TEXAS A&M UNIVERSITY
NUCLEAR SCIENCE CENTER REACTOR
LICENSE NO R-83
DOCKET NO. 50-128

SUBMITTAL OF RESPONSES TO NRC
REQUEST FOR ADDITIONAL INFORMATION
FOR THE CONVERSION FROM HIGH-ENRICHED
URANIUM TO LOW-ENRICHED URANIUM FUEL

Subject: Texas A&M University System Texas Engineering and Experiment Station Nuclear Science Center (TAMU NSC), Docket 50-128, License R-83. Submittal of Responses to NRC Request for Additional Information and of Revised Tech Specs (RE: High-Enriched to Low Enriched Uranium Conversion for TAMU NSC)

**REQUEST FOR ADDITIONAL INFORMATION
TEXAS A&M UNIVERSITY NUCLEAR SCIENCE CENTER REACTOR
DOCKET NO. 50-128**

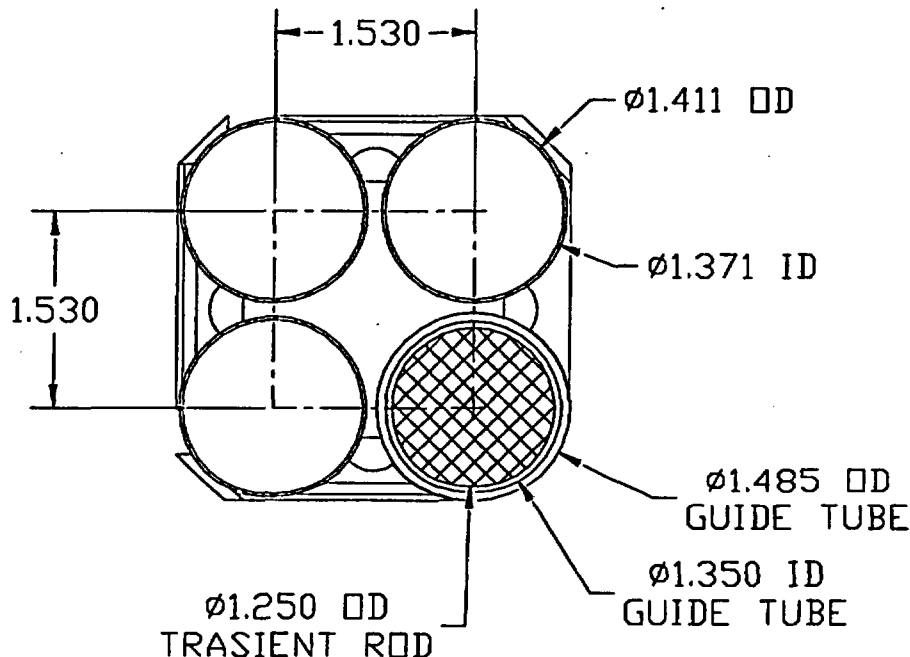
14. Section 4.7.2. There are at least three different channel flow areas in the TRIGA core and each is associated with different bundle geometry, the four-element bundle, the three-element bundle (with fuel-followed control rod), and the three-element bundle with guide tube (for regulating rod or transient rod). Did the flow area used in the STAT analysis take into account the location of the fuel element in the core? Was a limiting flow area used in the analysis?

Response: The response to question 13 also applies to this question. For both the average and maximum powered fuel rod, a representative flow area was used. As shown in the figure below, the guide tube for the transient rod has an OD of 1.485 in. which is slightly larger than the fuel element OD of 1.411 in. The guide tube reduces the flow area of the maximum powered fuel rod by about 3.5%. The flow rate for the maximum rod reduces from 0.089 kg/s to 0.087 kg/s. The effect on the MDNBR is a reduction from 2.42 to 2.34.
